Tech Note 032114_04

Product: Zone Controller (ZC)

Subject: FI-2 Hardware Revisions

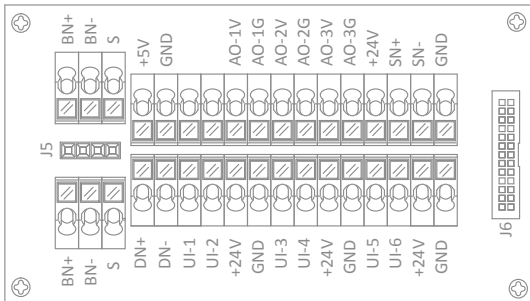
1. Building Network Terminal Block:
 - Blocks are now plug type and removable.
2. Universal Input Terminal Block:
 - Standardized Input, Ground and 24VDC terminations to be adjacent.
 - Blocks are now plug type and removable.
2. Satellite/Station Network Terminal:
 - Blocks are now plug type and removable.
 - Revised terminal block orientation for standardization across product line.
